Junction Creek Subwatershed Study and Stormwater Master Plan

**Subwatershed Management Strategies
Recommended Preferred Solution**

**Public Meeting No. 4
March 21 and 22, 2018**

Written submission – Junction Creek Subwatershed Study and Stormwater Master Plan (PIC 4)

Diversion Facility Upstream of Ponderosa

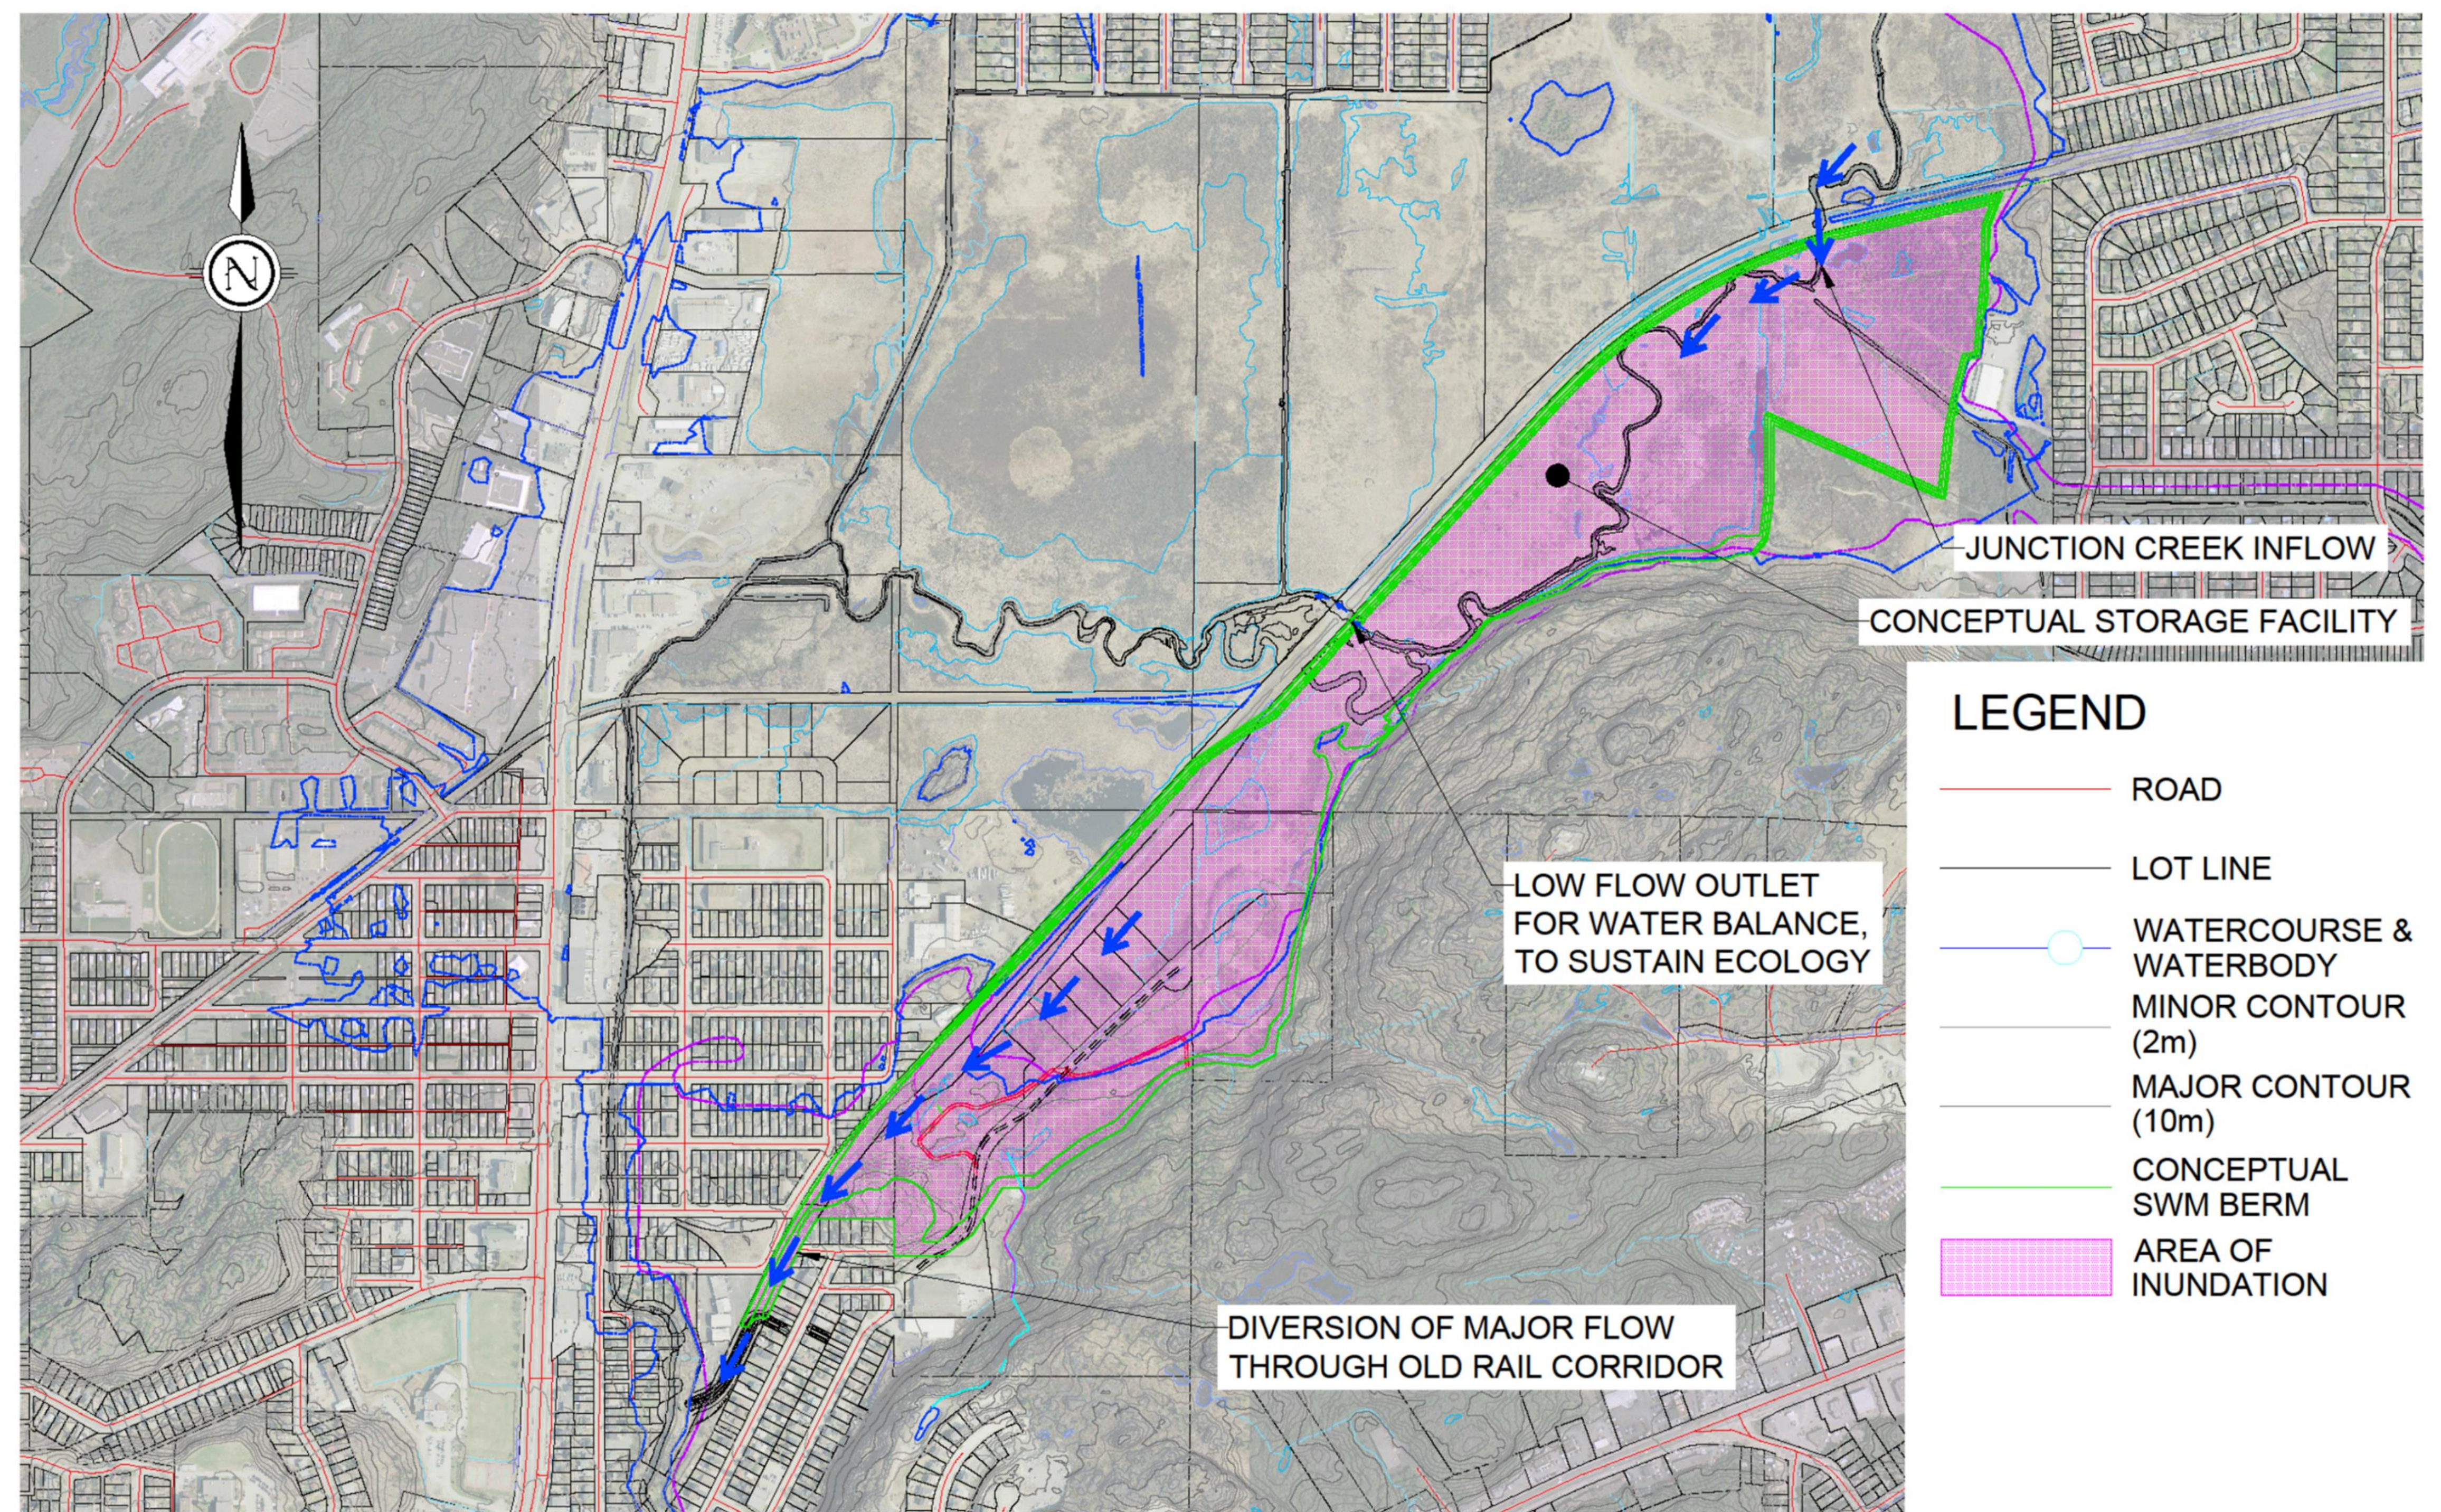
There are expressed concerns for the suggested options that alter the natural environment, in particular Alternatives #7 and #10. Making alterations that would redirect flow of the Ponderosa wetland can have significant impact on the dynamics of the ecosystem. With recent research indicating significant habitat of species at risk in the suggested site of Ponderosa, it is discouraged to pursue Alternative #7. In addition, there is concern for possible environmental implications and dormant substances that may be disturbed and released with the dredging of Junction Creek (Alternative #10).

One of the alternatives presented is a diversion facility (storing stormwater) in the Ponderosa wetland. This would be very damaging to this ecosystem. It would also not likely be permitted due to the presence of species at risk, and a highly ranked wetland evaluation.

Diversion to Gravel Pits east of Falconbridge Drive

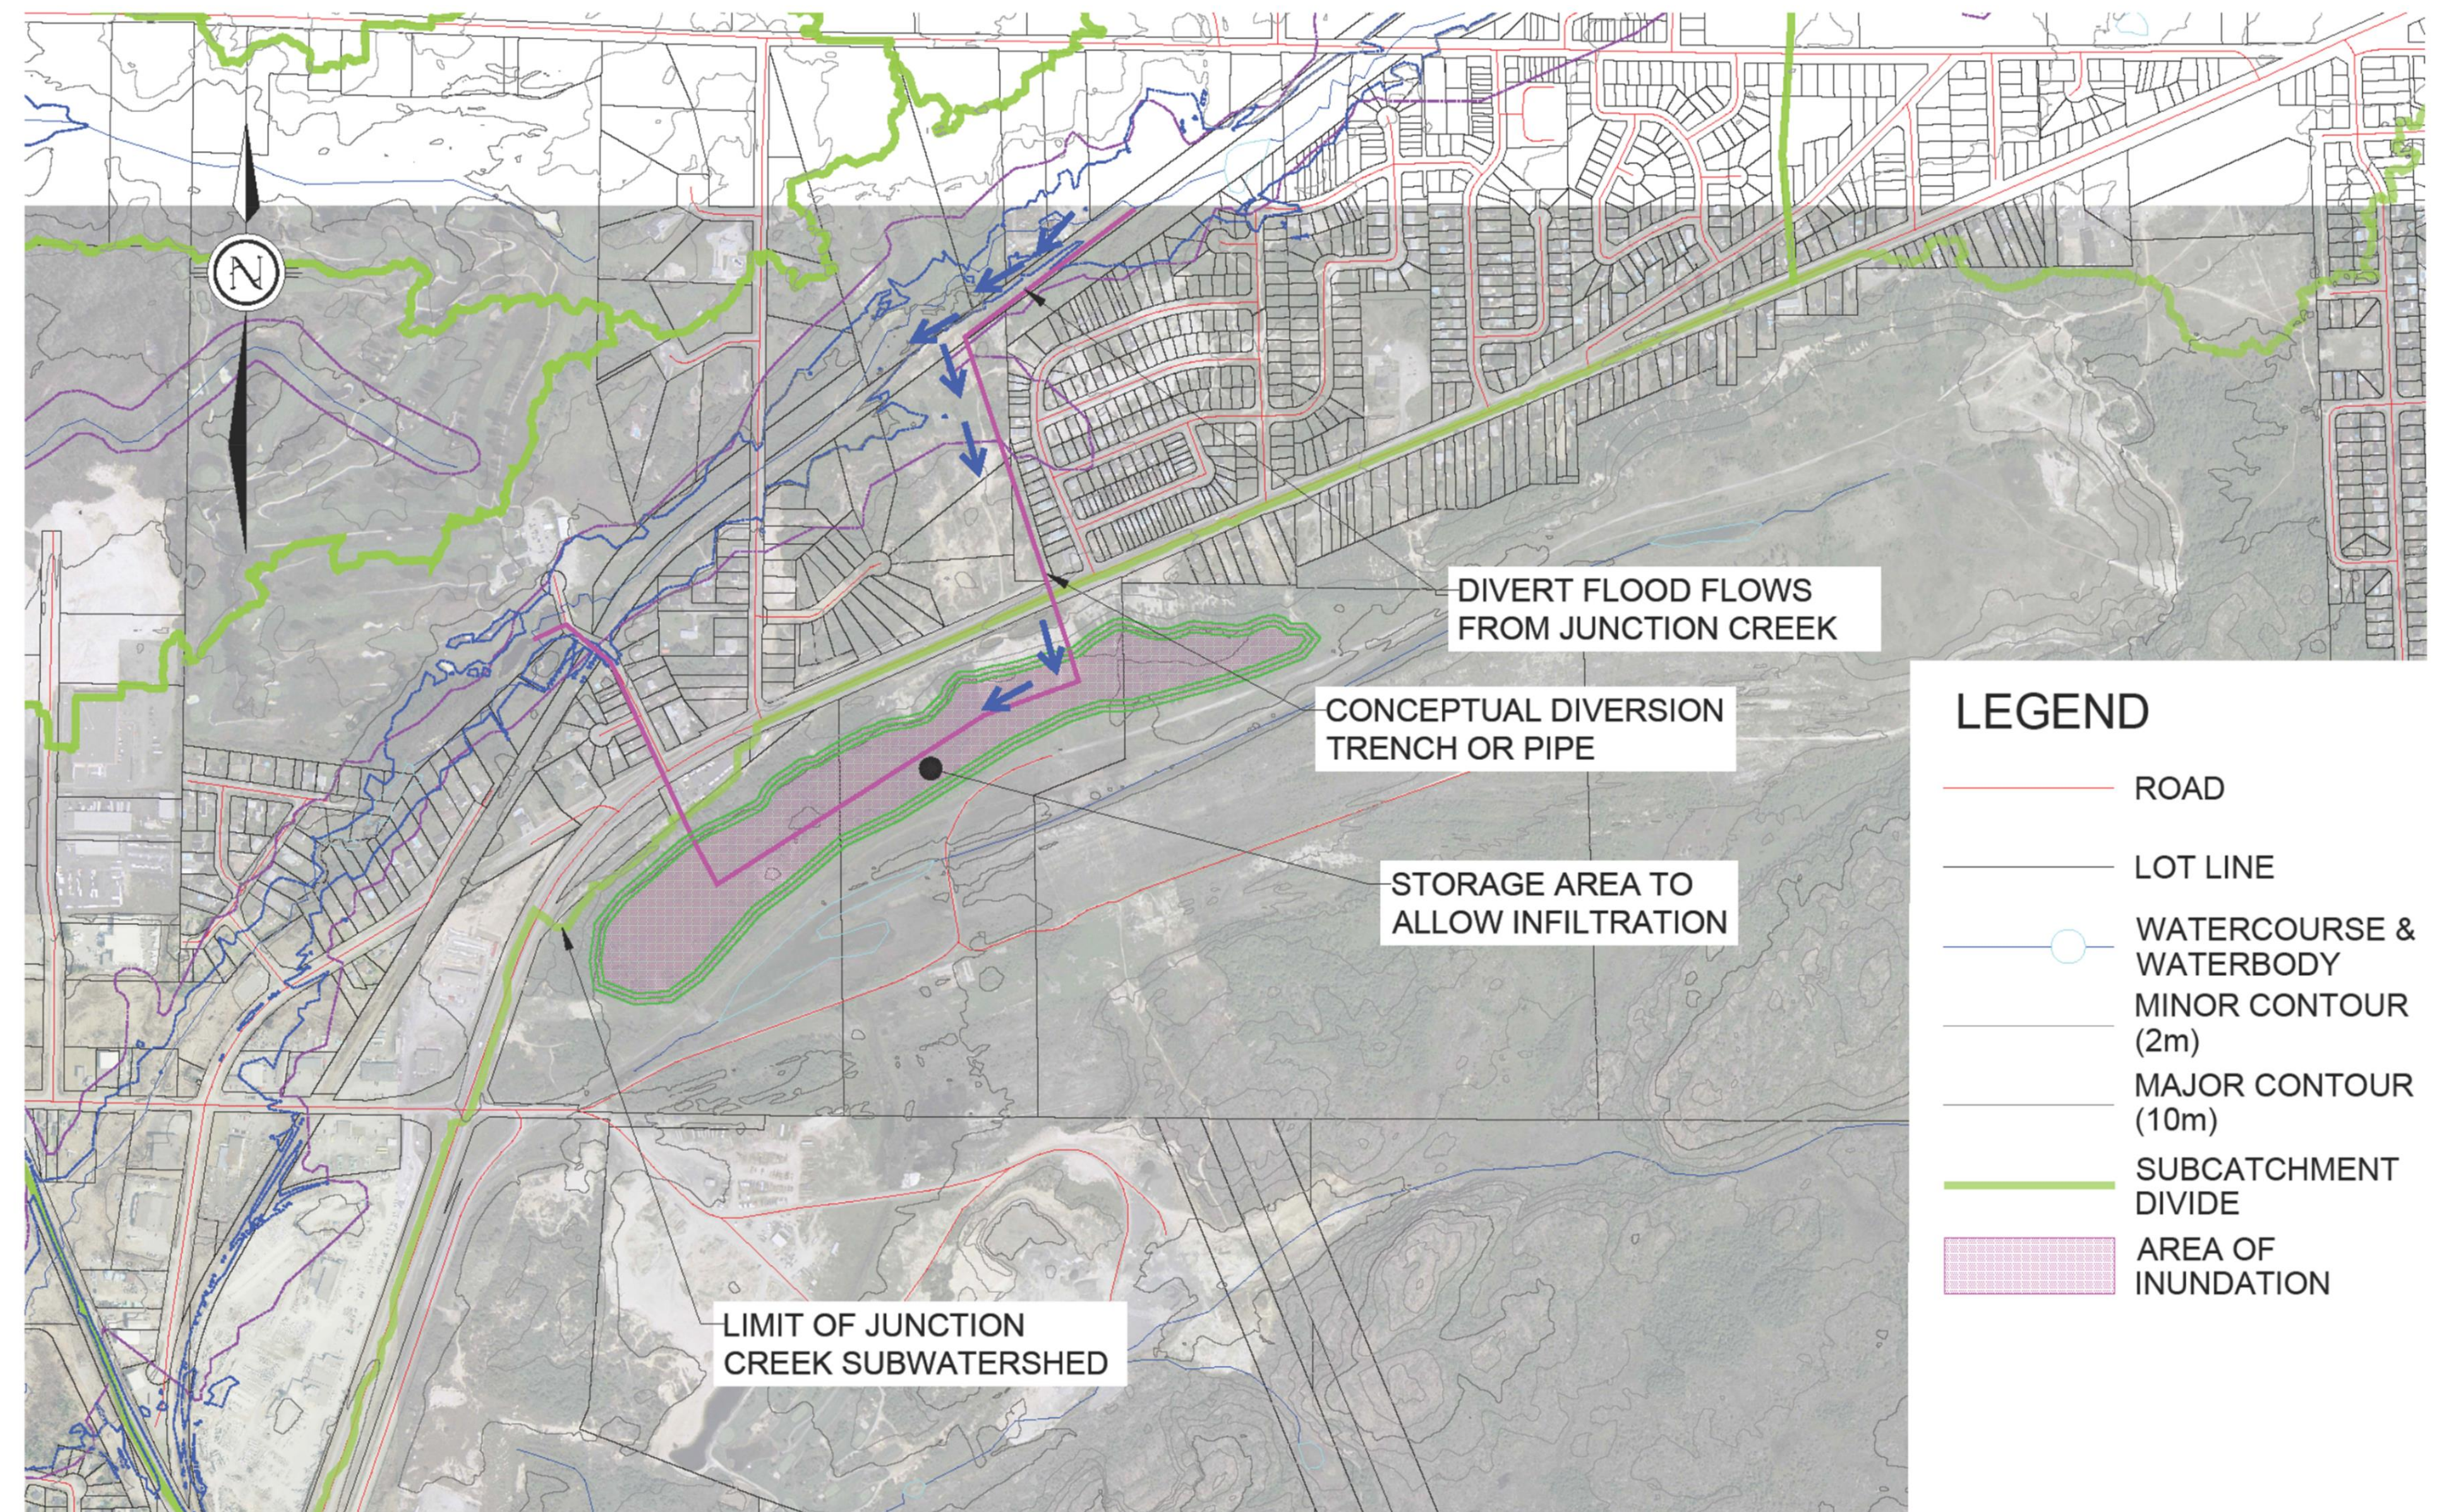
- *Alternative 7. Redirect excess flow to nearby systems.* Bringing water from Junction Creek into other systems can have consequences for both water quality and quantity. The introduction of creek water may lower water quality in cleaner water bodies or systems, and/or introduce invasive species. Taking water out of the system when levels are high means that that water will not return to the system later as would happen naturally, which could lead to low water levels later in the season.
